WOODMEN HILLS METROPOLITAN DISTRICT  
LIFT STATION #1 REPLACEMENT  
LANDSCAPING PLAN & NOTES

C18  
SHEET 18 OF 19

PCD File No. PPR1841

# Markup Summary

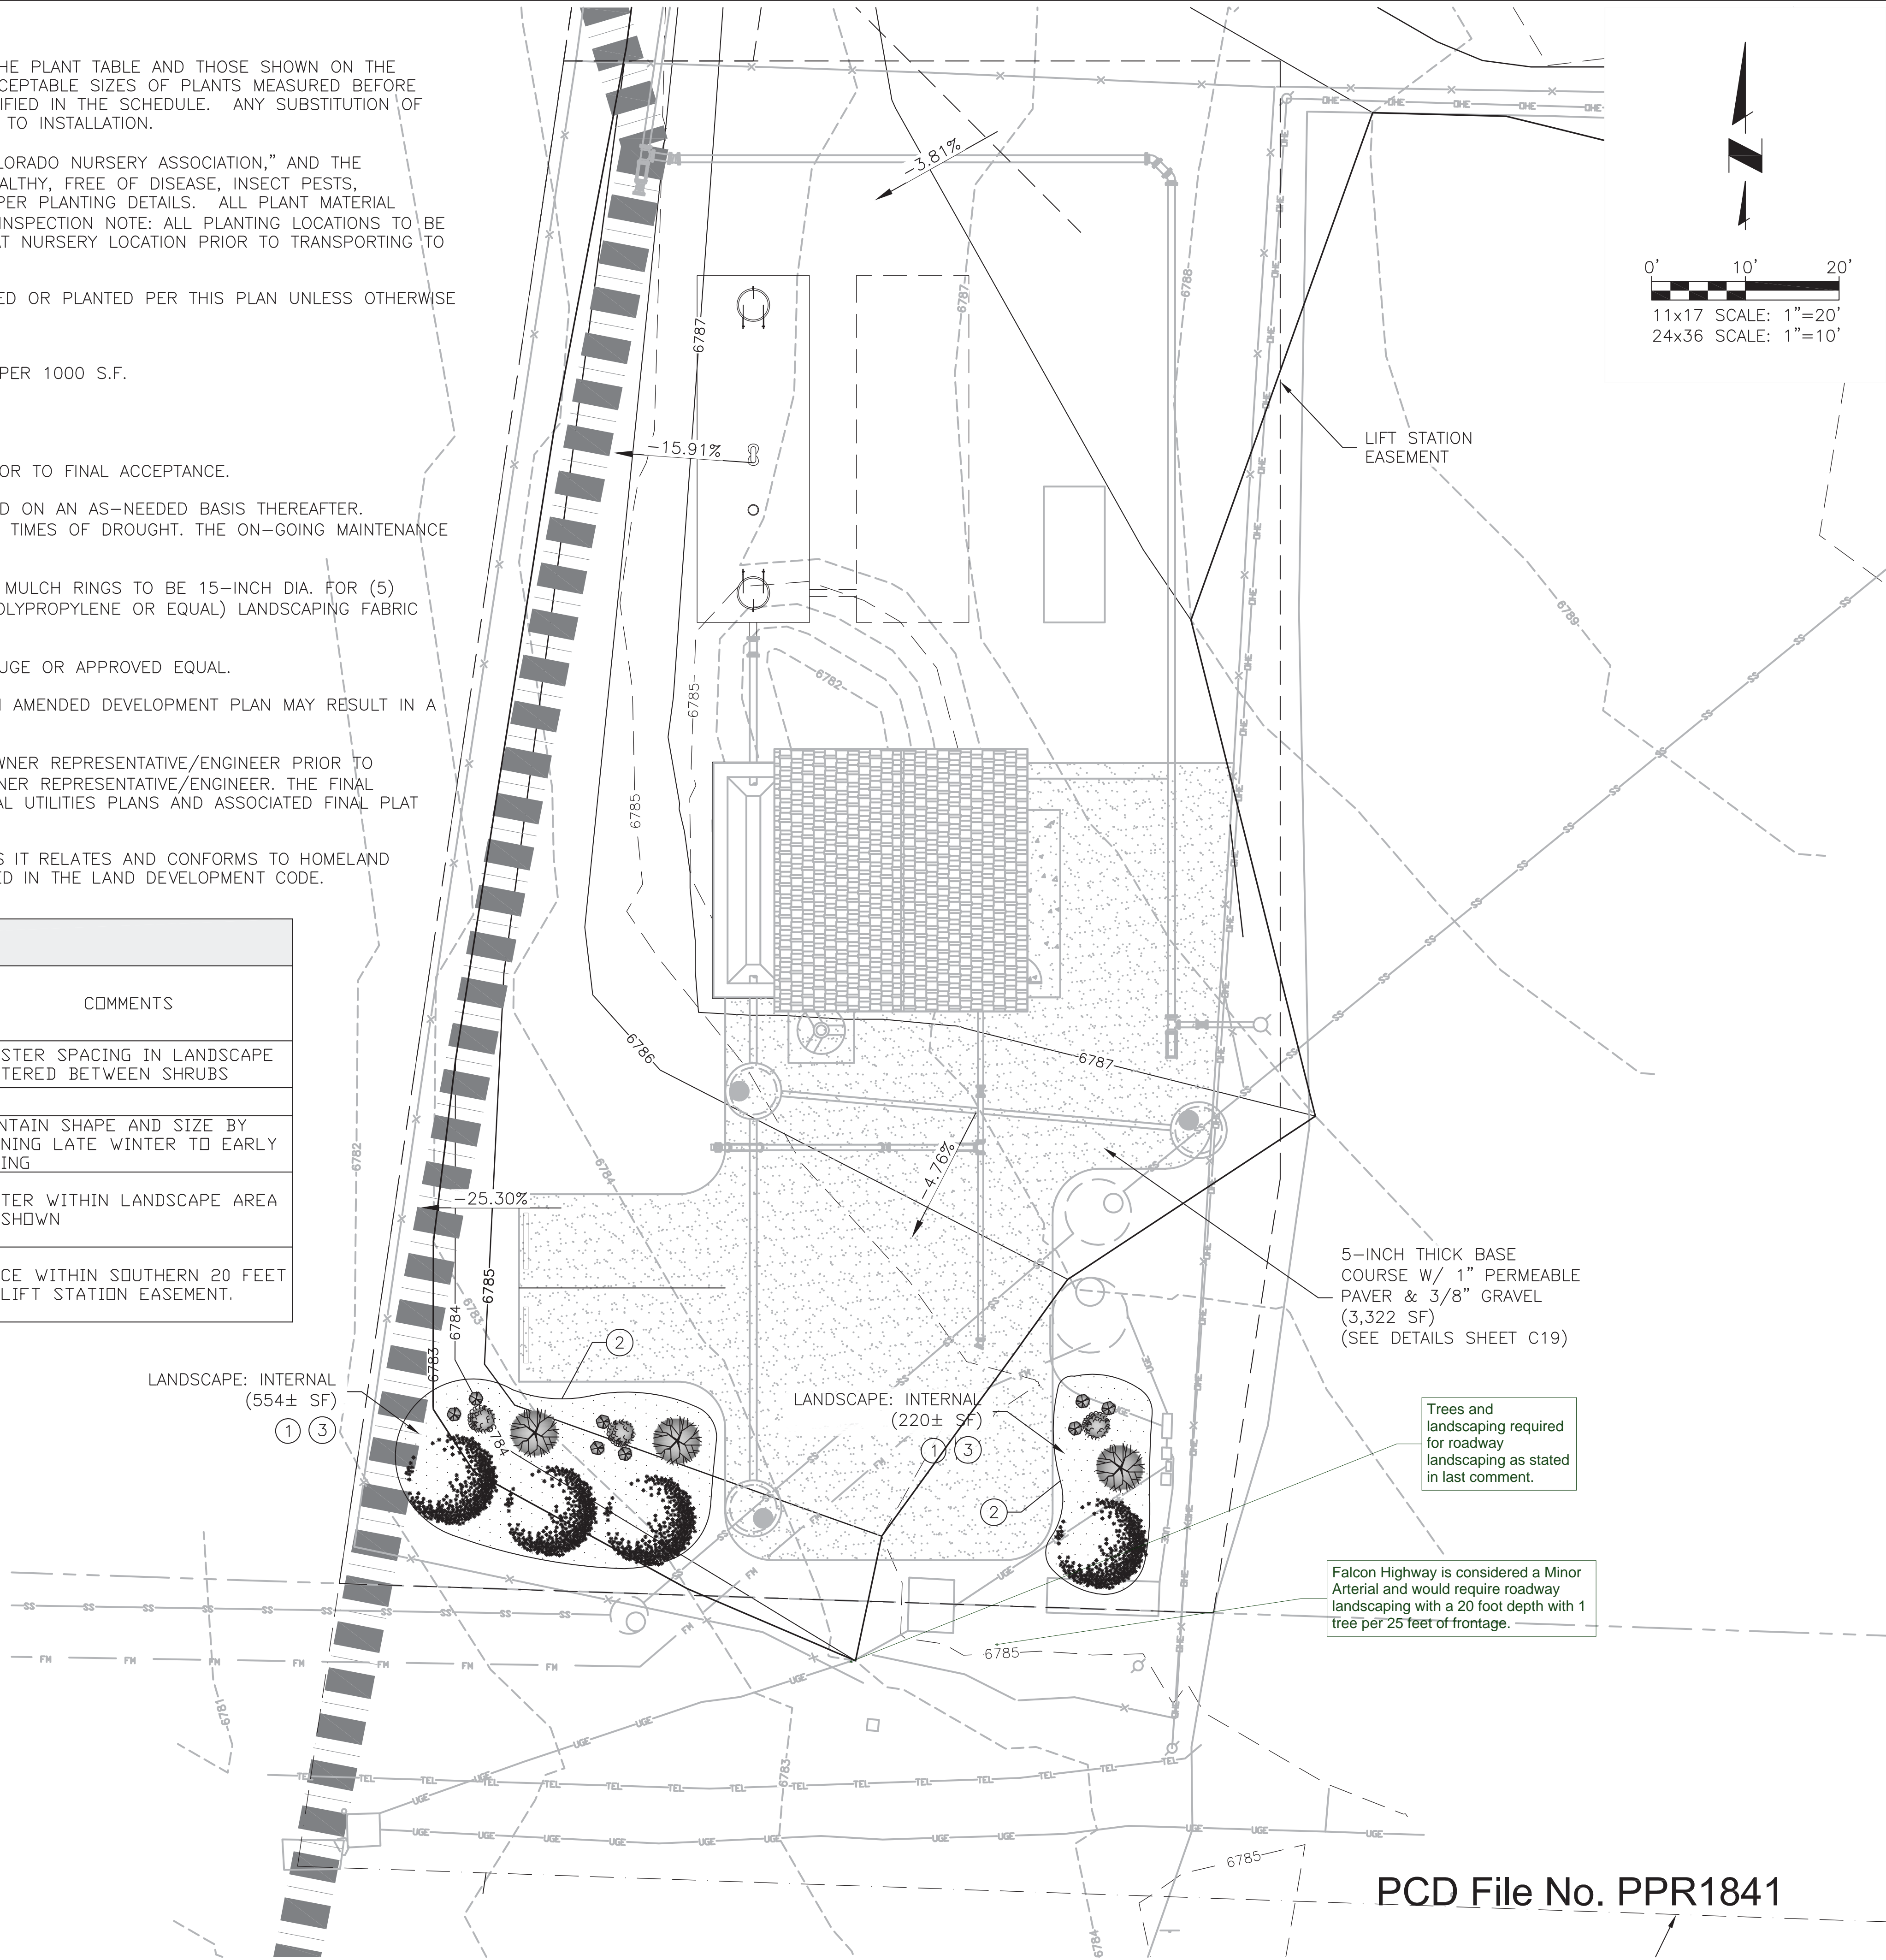
Trees and landscaping required for roadway landscaping as stated in last comment.

Falcon Highway is considered a Minor Arterial and would require roadway landscaping with a 20 foot depth with 1 tree per 25 feet of frontage.
